FINAL DRAINAGE LETTER
FOR
LOT 35, CLAREMONT BUSINESS PARK
FILING NO. 2
EL PASO COUNTY, COLORADO

Project #44-029
PCD Project No. PPR-17-000

PPR-17-056

RE: Final Drainage Letter for Lot 35, Claremont Business Park Filing No. 2, in El Paso County, Colorado.

PROPOSED DRAINAGE MAP

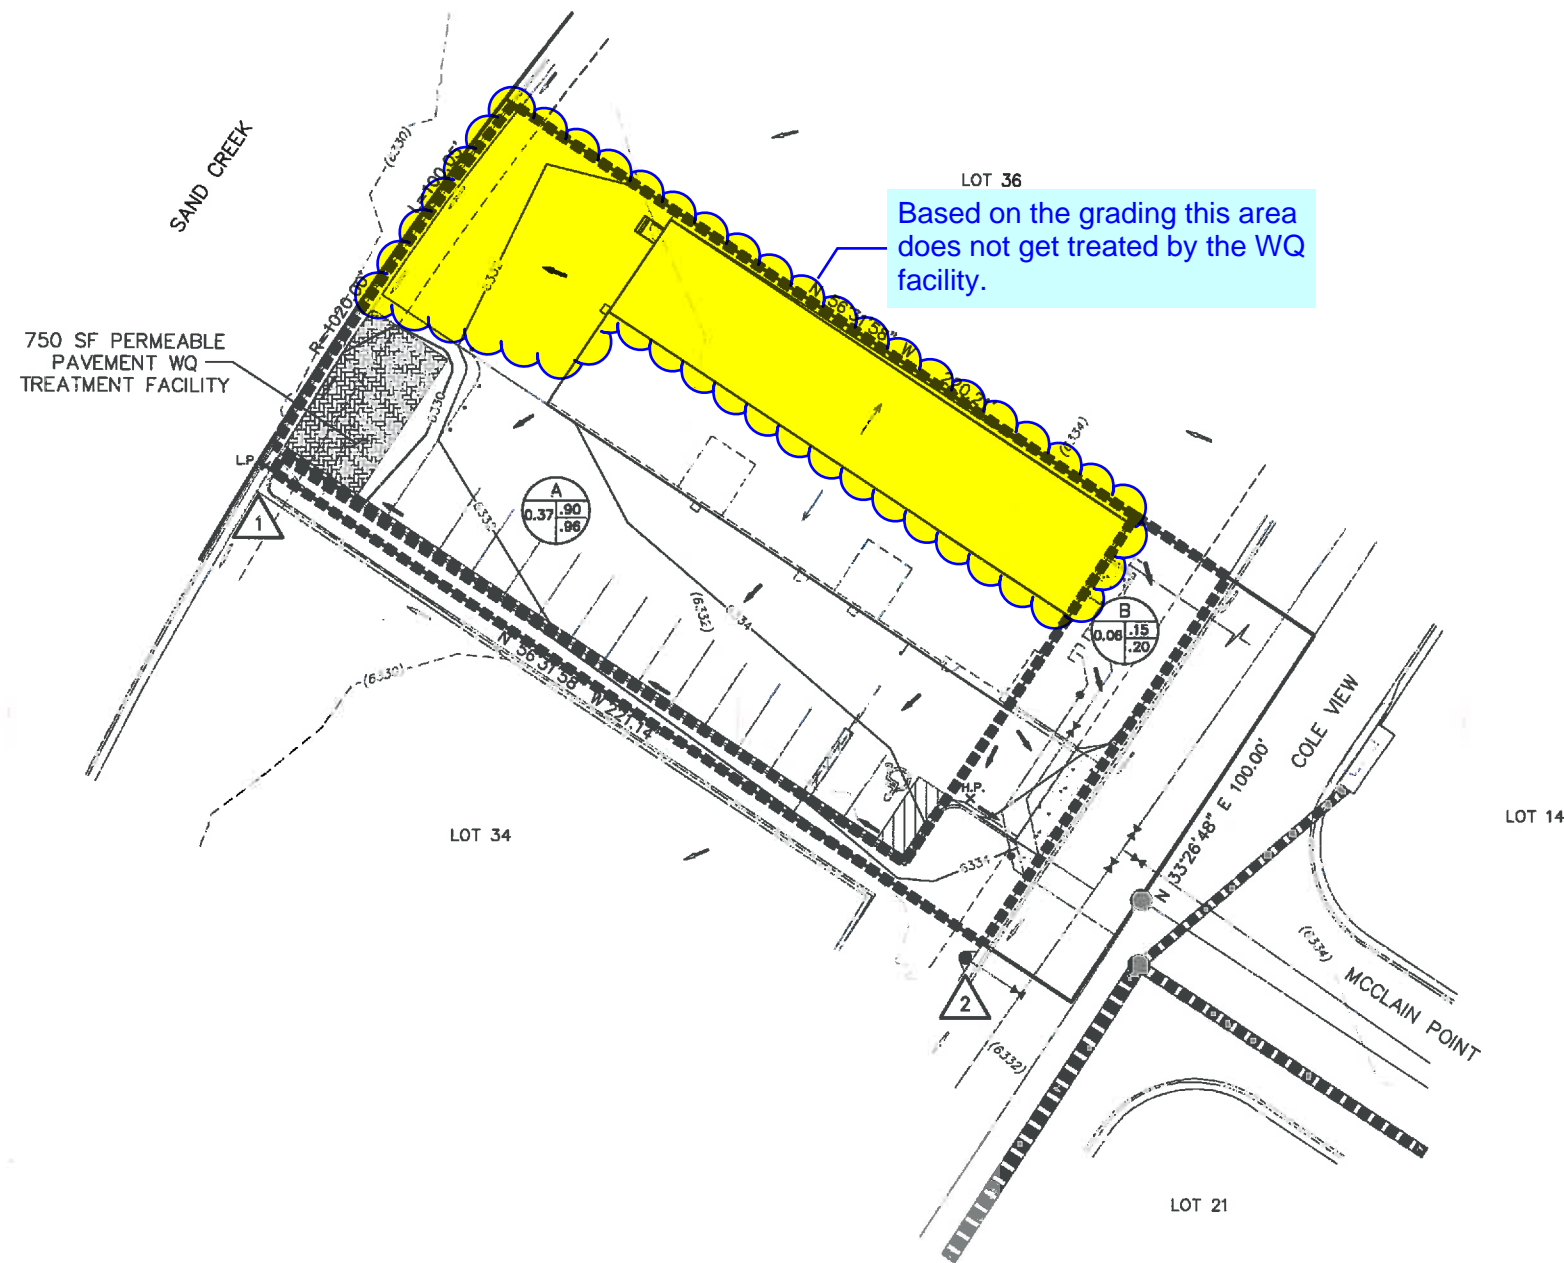
Does not match the plans.
